**Summary of the Condition of the Organ Chamber and Tower Roofs
at St. Peter & St. Paul's Church, Wincanton**

The following is a summary of an inspection of the tower and organ chamber roof at St. Peter & St. Paul's church, Wincanton undertaken on 3rd October 2019.

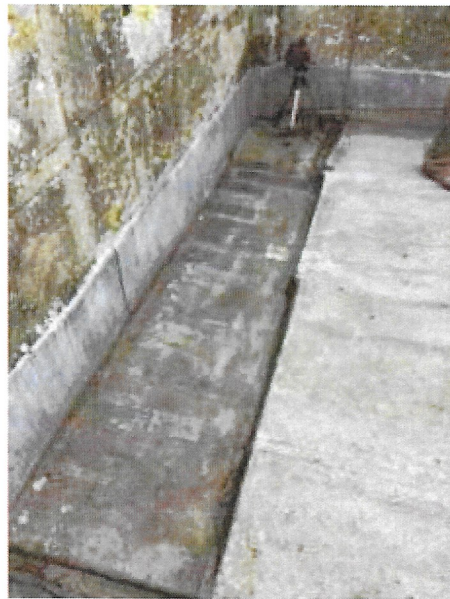
- 2.1 The tower roof is formed of two bays of lead falling to the north into a lead parapet gutter. The lead sheets have welted joints.

- 2.2 As with the organ chamber roof the leadwork to the tower roof has a number of splits that have been repaired and several sheets have slipped down the slope. Although the lead sheets are smaller than on the organ chamber they are still relatively large for their thickness and are of a reasonable age.
